Re: Laurel Canyon (Amendment)

MDP# 761-B

The City Staff Development Review Committee has reviewed the Laurel Canyon Development Plan, **M.D.P. # 761-B (Amendment)**. Enclosed, please find a signed copy for your files. Your plan was accepted with conditions as noted:

MASTER DEVELOPMENT PLAN # 761B

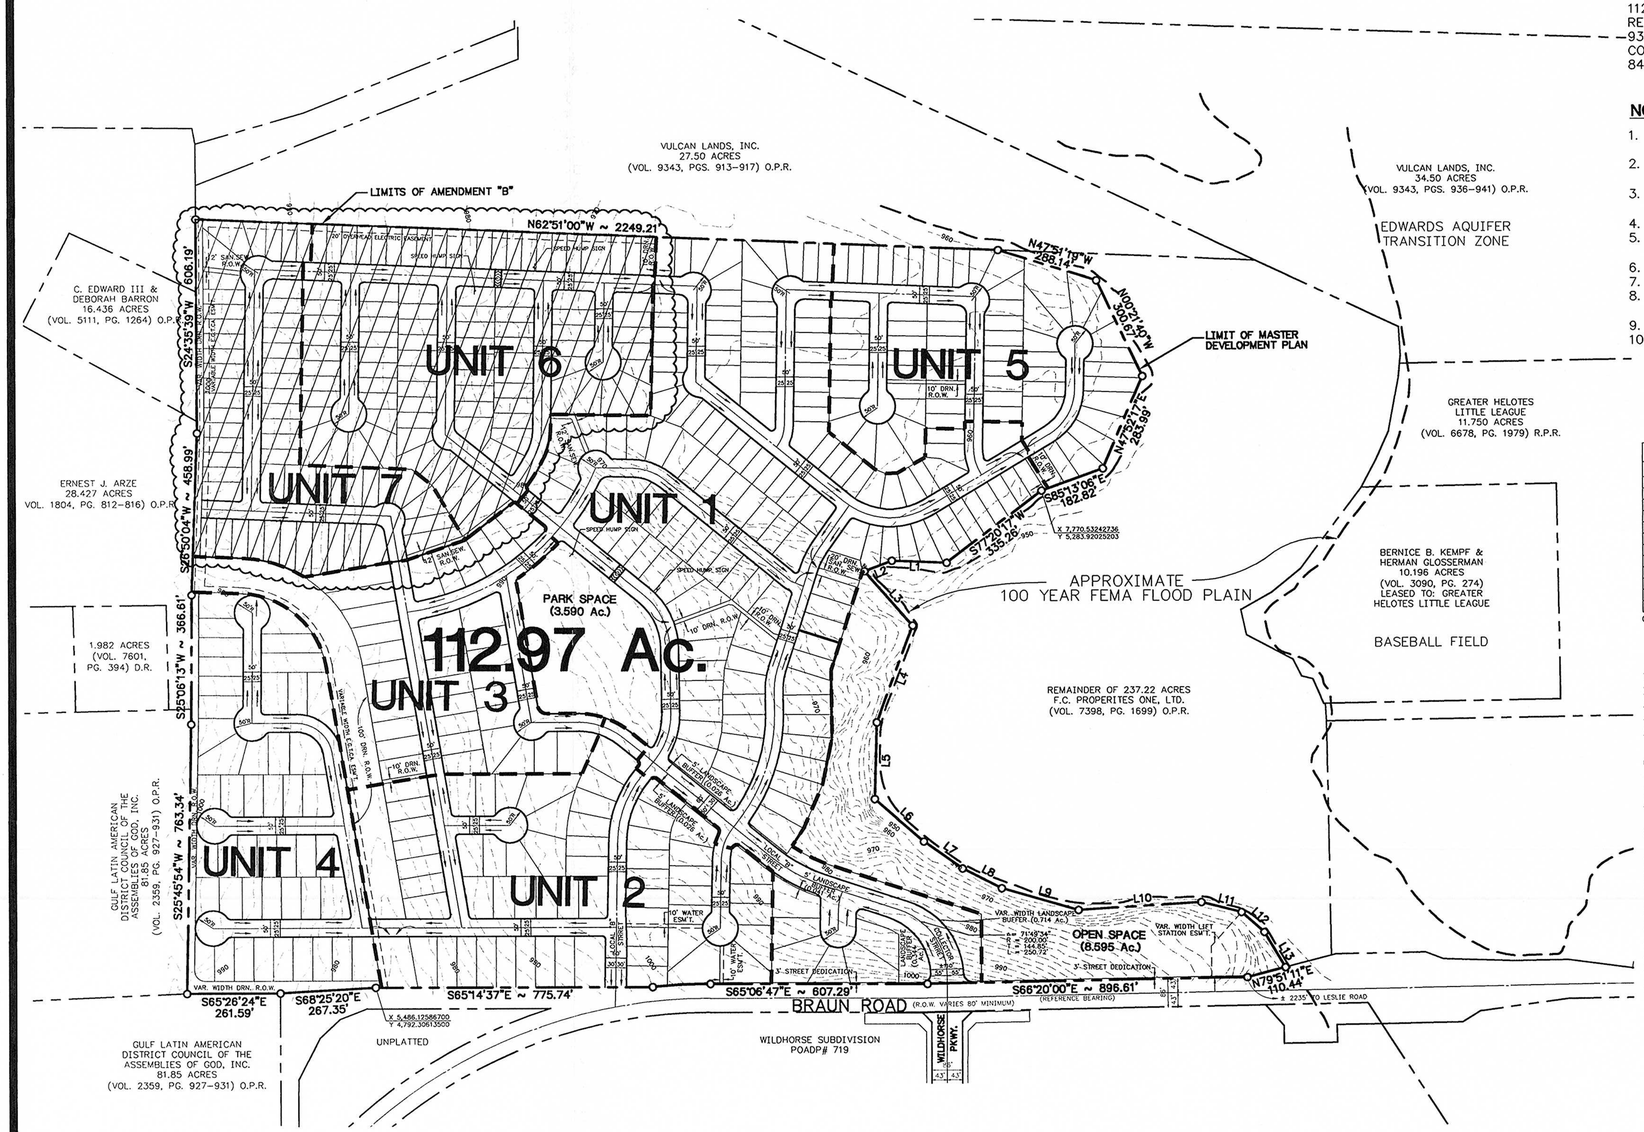
In our brief look at the plan, we saw several problems on the MDP. The liability for any damages caused by the subdivision to downstream properties and any damage caused to the subdivision itself due to drainage deficiencies, remain the sole responsibility of the developers of the property.

In our brief look at the plan, there are several concerns relating to traffic and the impact this subdivision will have on the surrounding area. Due to the deficiencies of the layout, any Traffic issues remain the sole responsibility of the developer of the property.

- In consideration of public safety and convenience, excessive grades by reason of topography should be avoided in street layouts and arrangements.

Laurel Canyon is a subdivision of 529 units. Based on Section 35-503 of the UDC, the park dedication requirement for this development is 4.8 acres.

1. The 3.59-acre park designated "Park" on the plan be deeded to the Laurel Canyon Home Owner's Association (HOA). All requirements of 35-503(f)(2) are in force and required for this park.

2. Trees shall be planted parallel to all perimeter rights-of-ways. The distance between trees shall be an average of 32.5 feet with no distance greater than 50 feet. Each tree must have a minimum caliper of three (3) inches. Applicant may plant a minimum of two of the following species: Cedar Elm, Live Oak, or Monterrey Oak. Trees must be cared for and maintained by the developer for a minimum of one year.

3. The applicant shall install eight (8) picnic units and eight (8) park benches in the Park. Each unit must consist of a picnic table, benches, cement slab, and garbage receptacle. Tables and benches must be concrete or metal.

4. The applicant shall install an Open Play Area. This area is to be a minimum of 20,000 square feet of contiguous, unobstructed space with a maximum slope of five (5) percent. Common Bermuda shall be established in this area. The width of the play area must me a minimum of 100 feet.

5. The applicant shall install utilities to include security lighting and either irrigation for the care of the trees or a water fountain.

6. The applicant has requested and will receive 1.50 acres credit for the installation of a jogging trail with a minimum length of 0.25 mile meeting the requirements of Table 503-4.

7. Park to be constructed and improved with the development of Phase 1 of the subdivision.

- For streets 1200' feet or longer, traffic calming is required.
